V ASHWAUBENON, CORMIER RD
ONEIDA ST - ASHLAND AVE
CORMIER ROAD
BROWN COUNTY

STATE PROJECT NUMBER
9266-11-01

PROJECT NO: 9266-11-01	HWY: CORMIER ROAD	COUNTY: BROWN	STORM SEWER	SHEET	E
------------------------	-------------------	---------------	-------------	-------	----------

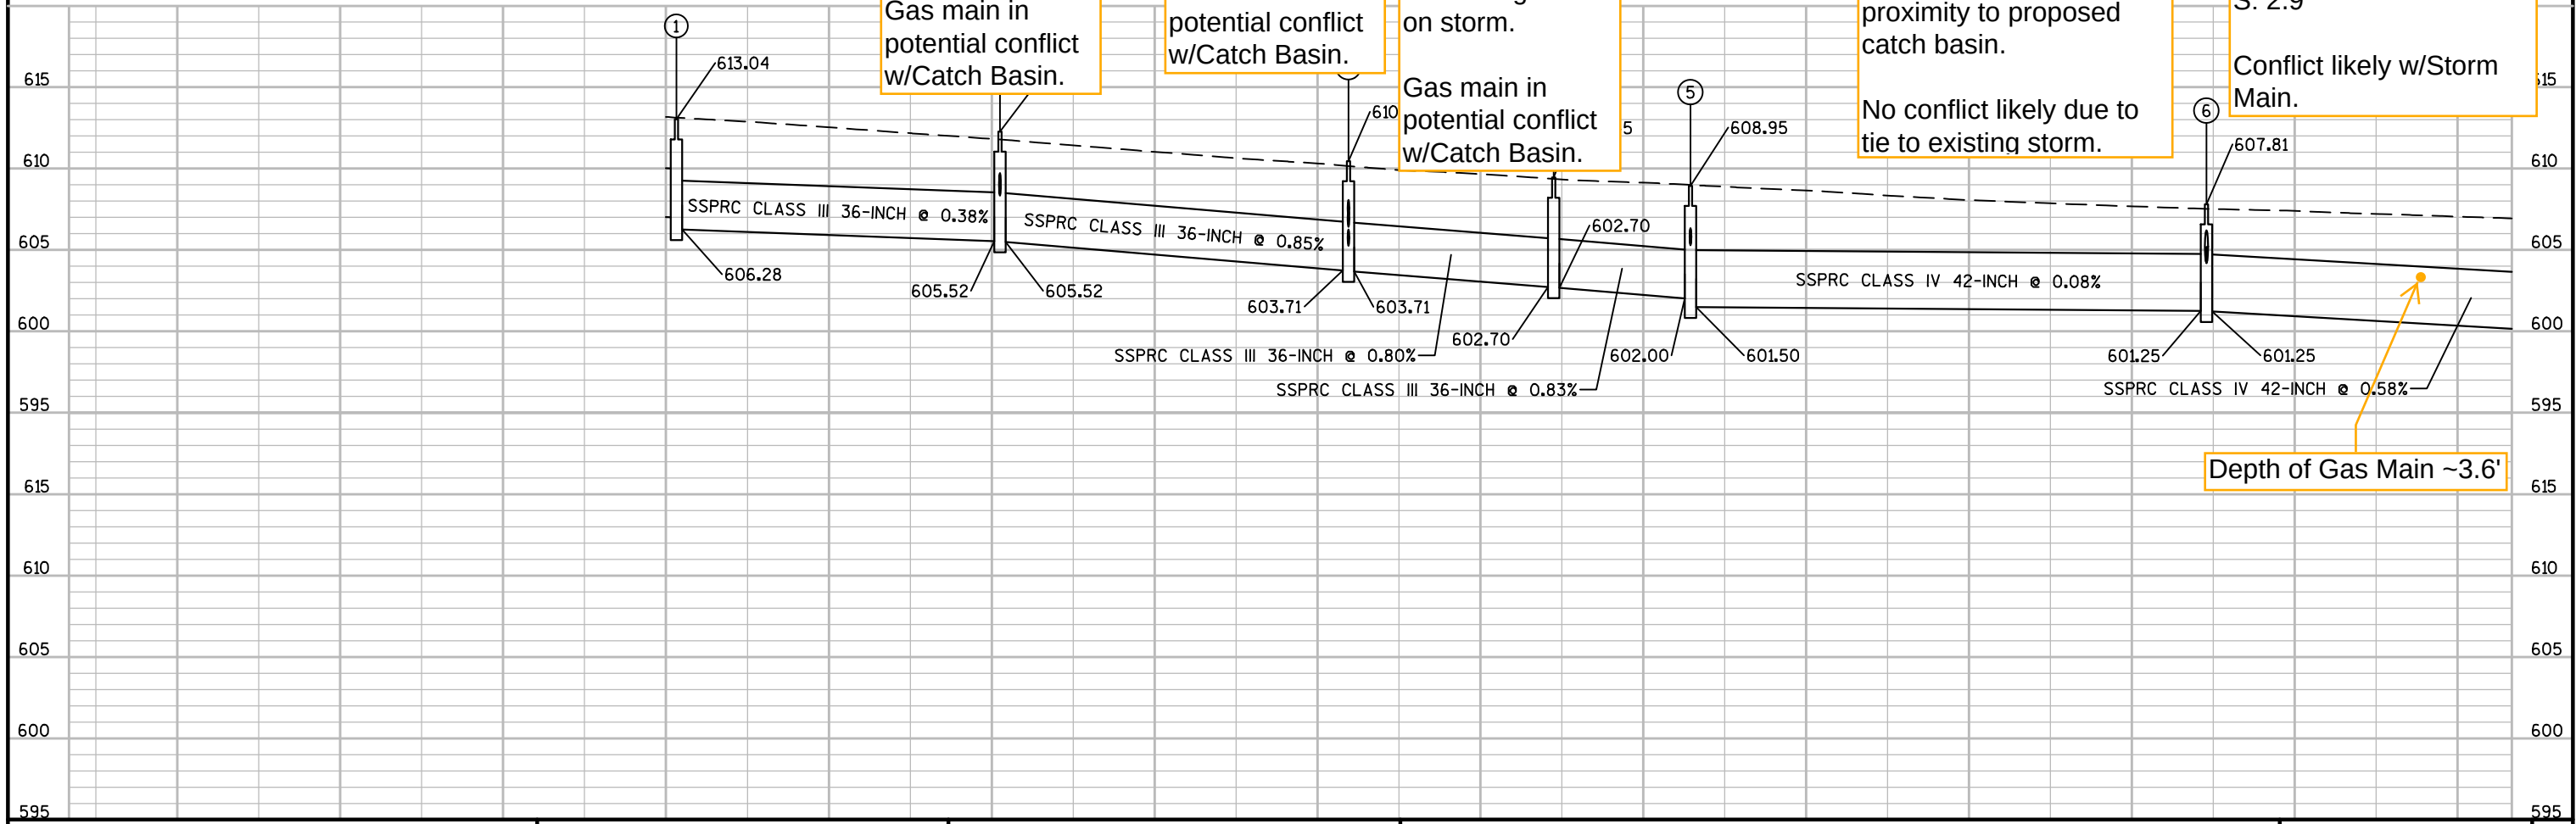
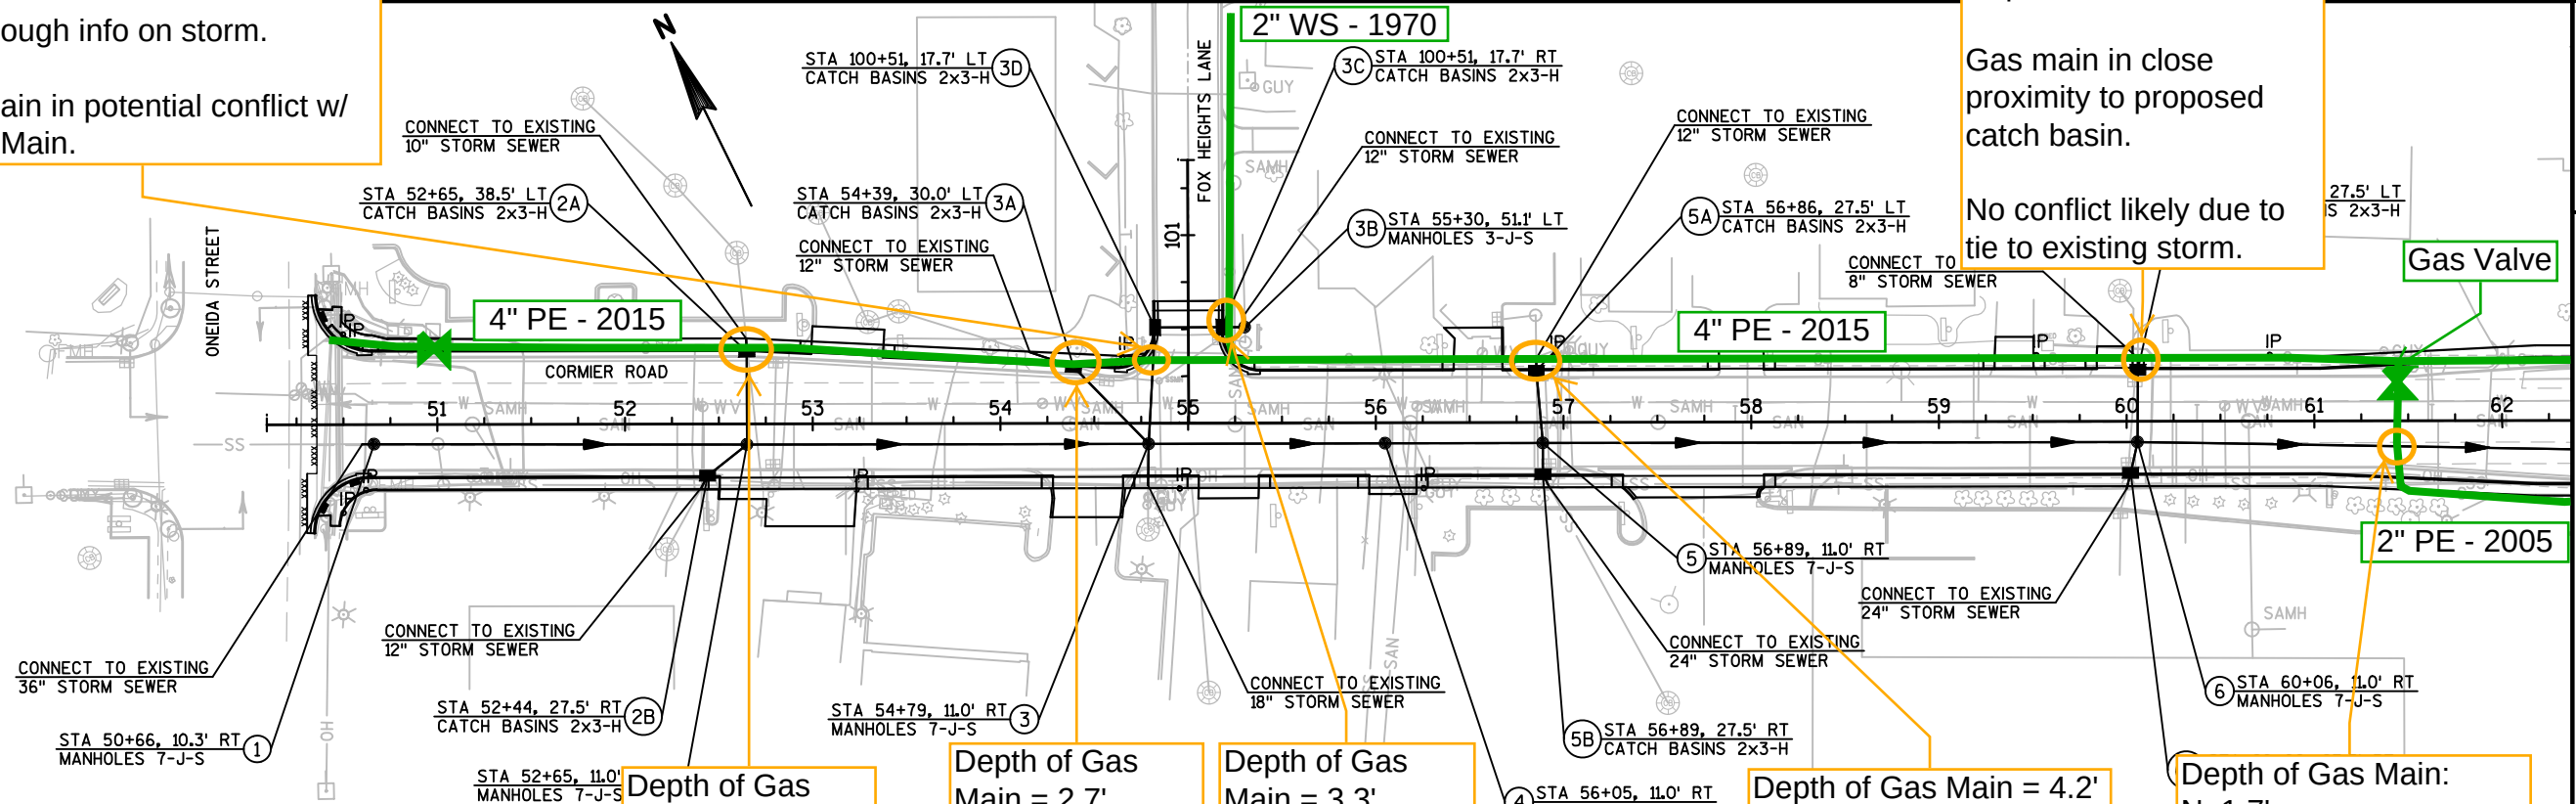
Depth of Gas Main =2.8'
Not enough info on storm.
Gas main in potential conflict w/
Storm Main.

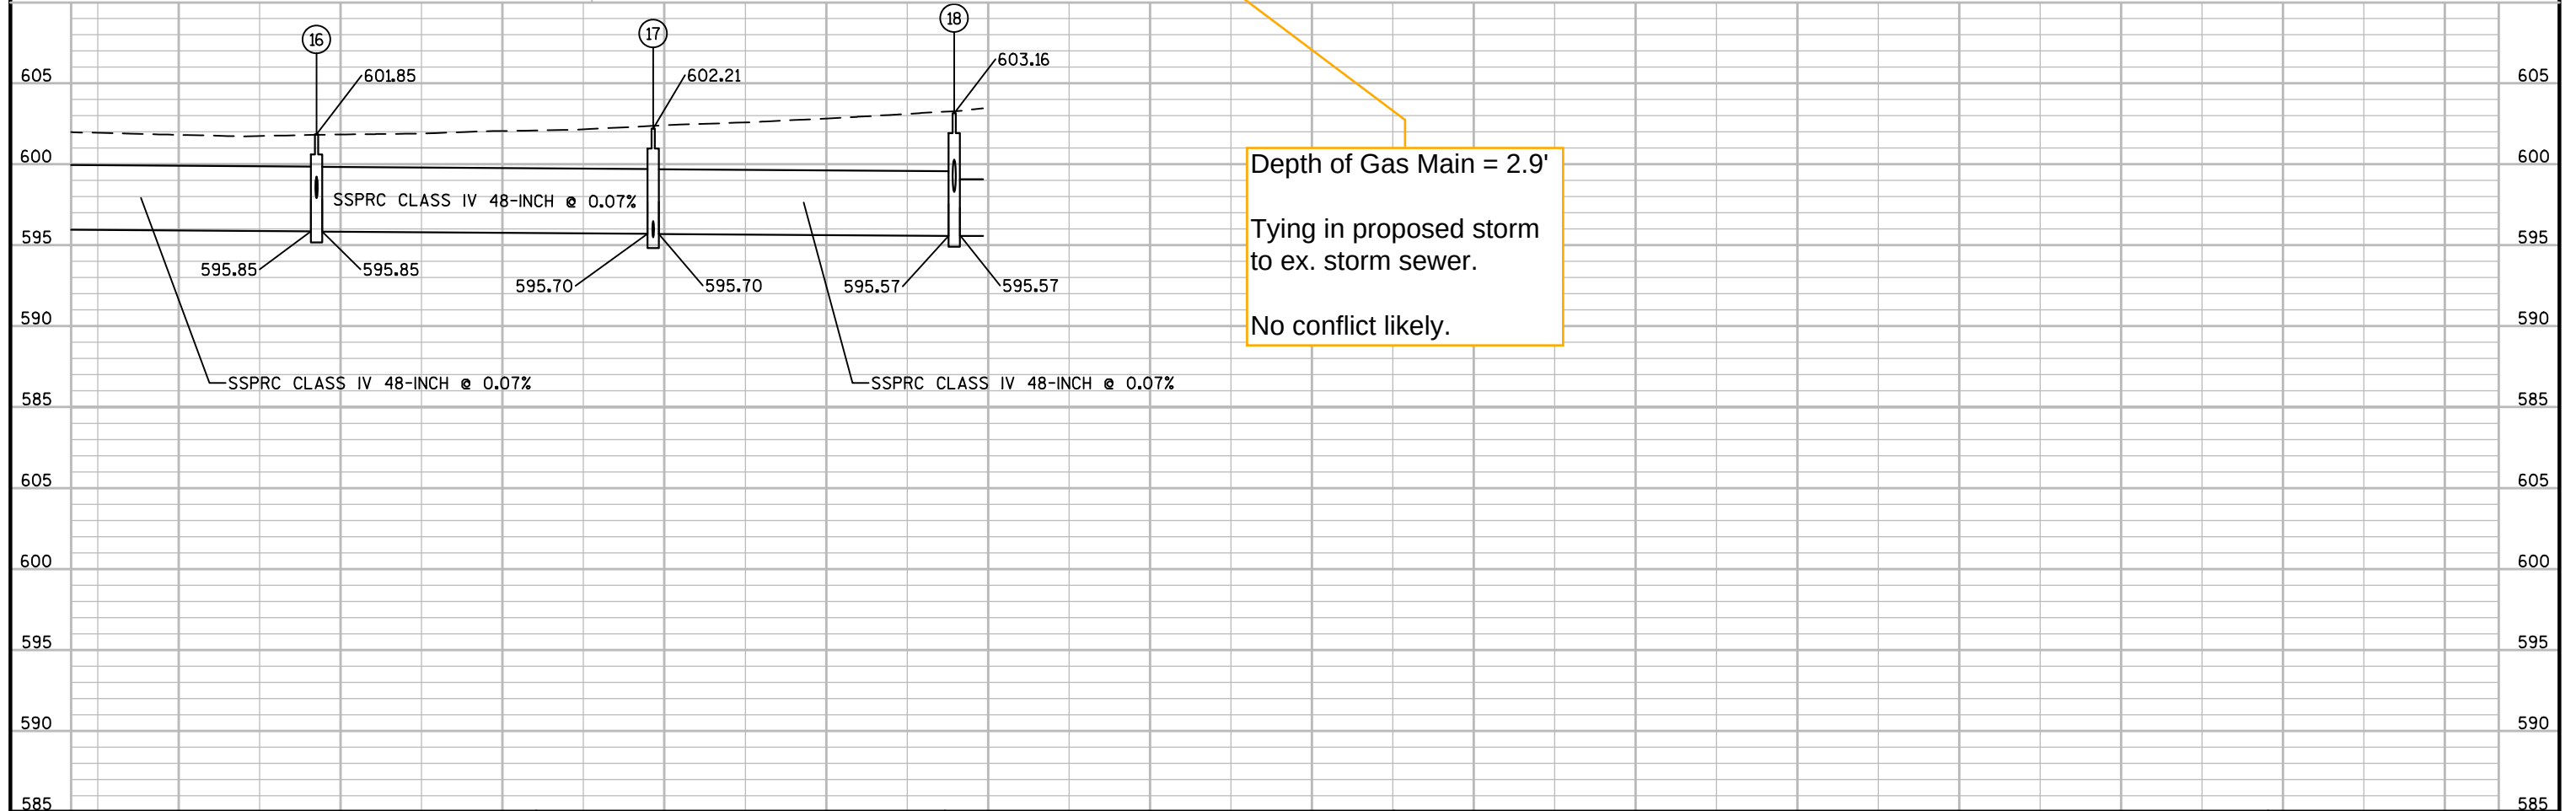
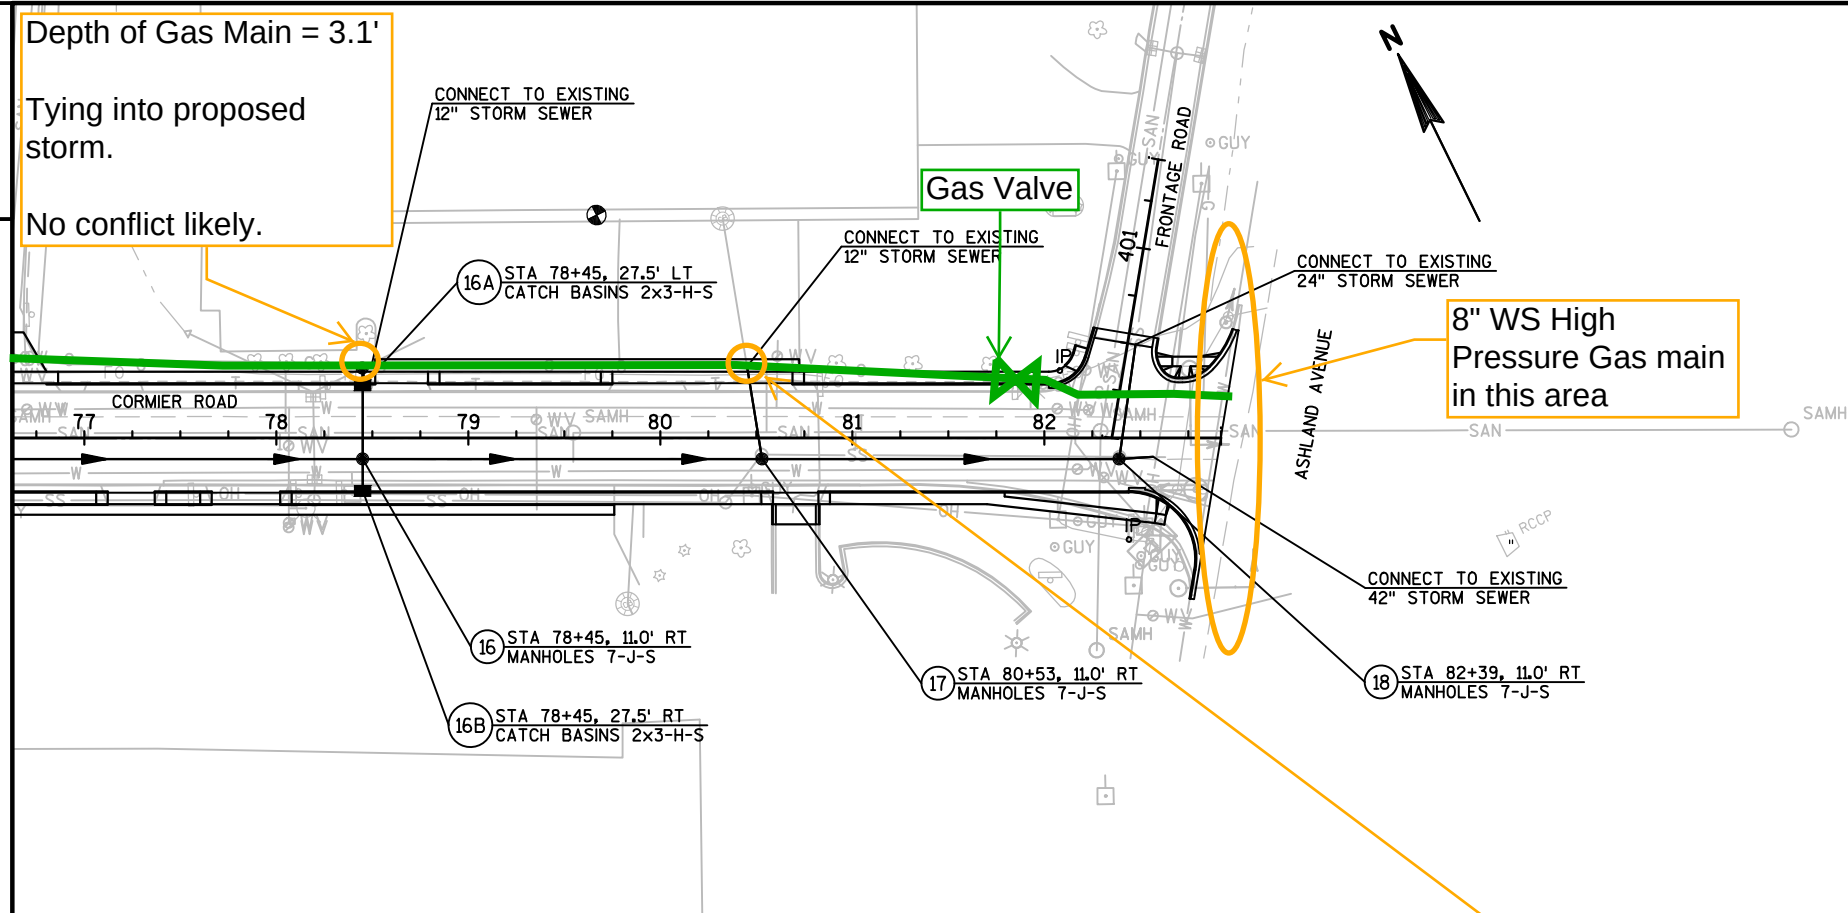
Depth of Gas Main = 3.3'
Gas main in close
proximity to proposed
catch basin.
No conflict likely due to
tie to existing storm.

2 Tying into proposed storm.

Depth of Gas Main = 3.1'

No conflict likely.

8" WS High
Pressure Gas main
in this area

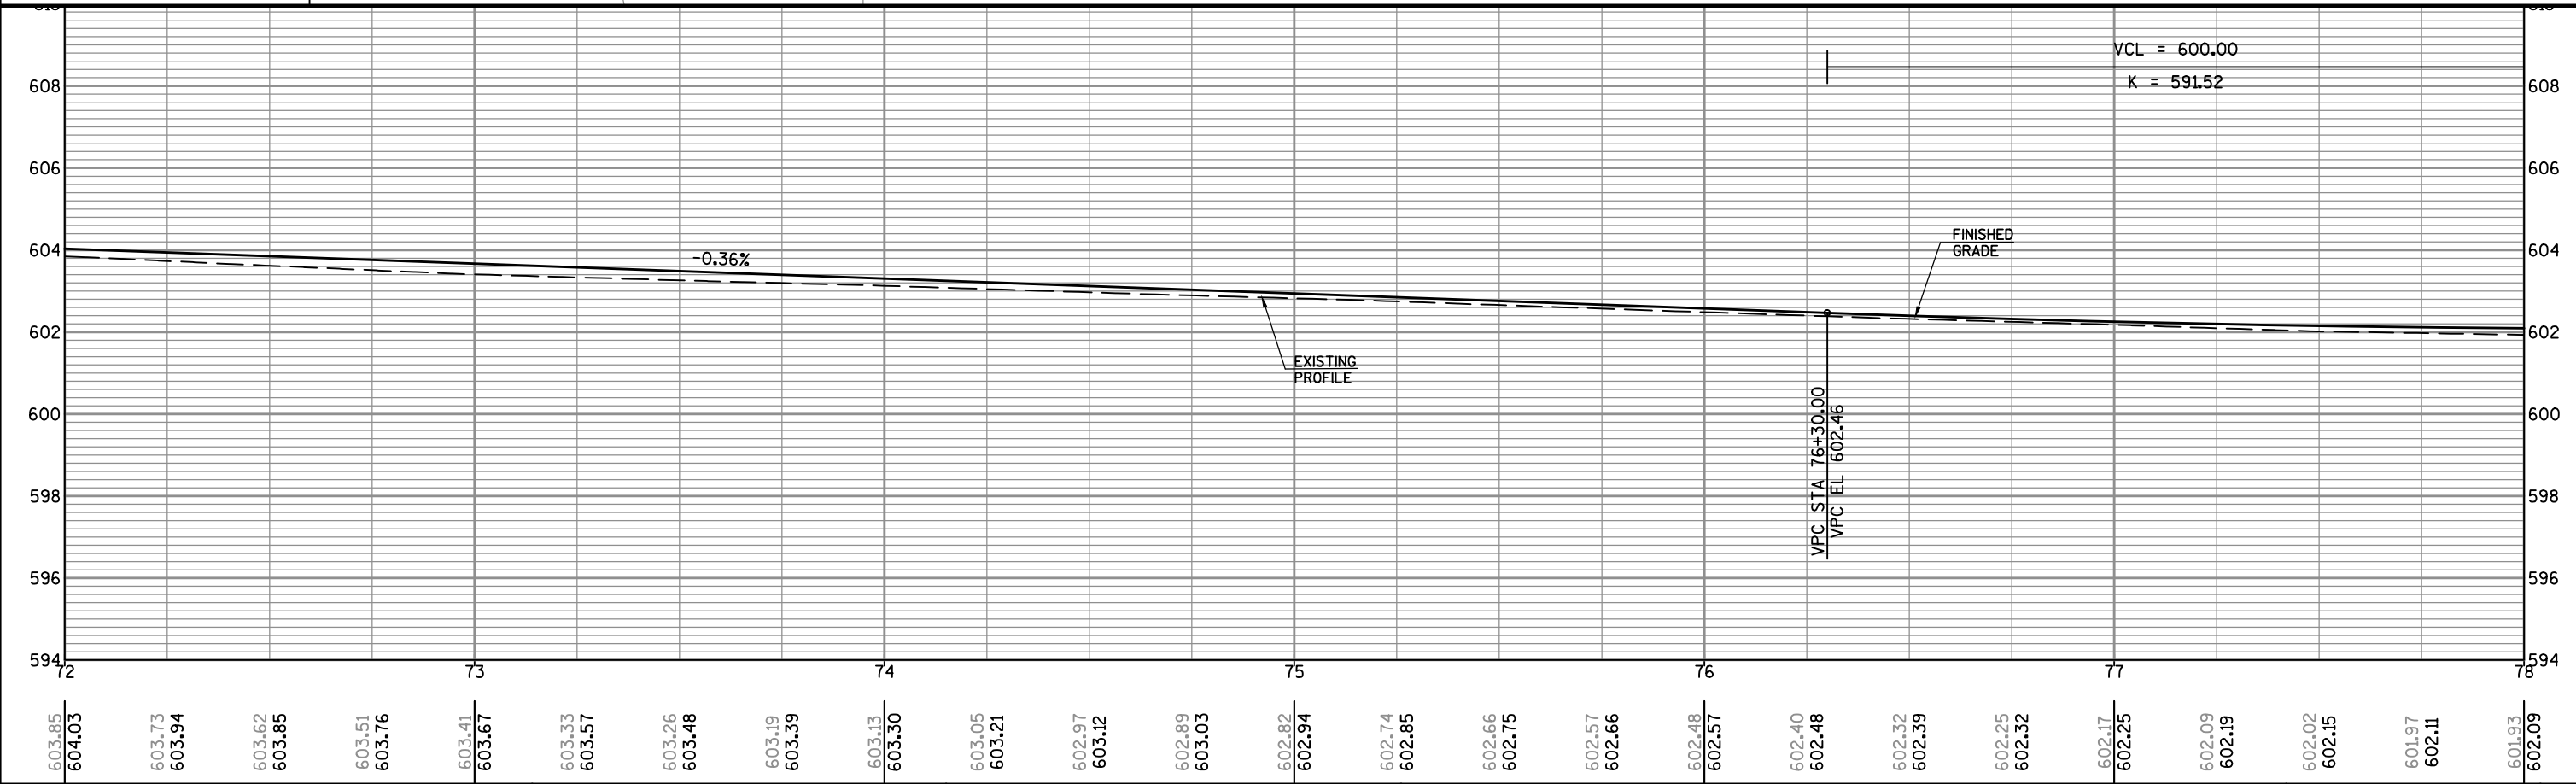
Depth of Gas Main = 3.1'

Tying into proposed storm.
